ADDENDUM 1

PROJECT: 10-21-001 ADA Operators Bid
BID / TIME DUE: October 21, 2021 at 2:00 p.m.

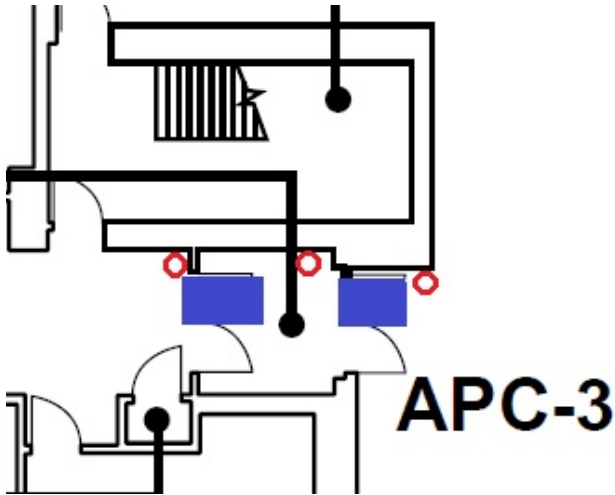
- 1) **DELETE** from Page 11, diagram for **Academic and Professional Center (APC) South Entrance - APC-3 (Base Bid)** and **ADD** revised diagram for APC-3 (Base):

WGL-3

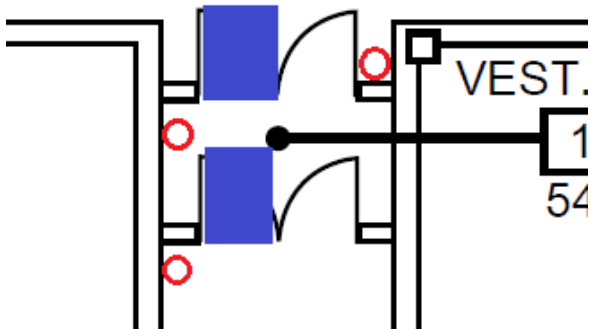
- 2) **DELETE** from Page 13, diagram for **ALT 4 – Weigel Hall (WGL) Southeast Entrance (WGL-3)** and **ADD** revised diagram for ALT 4 – (WGL-3):
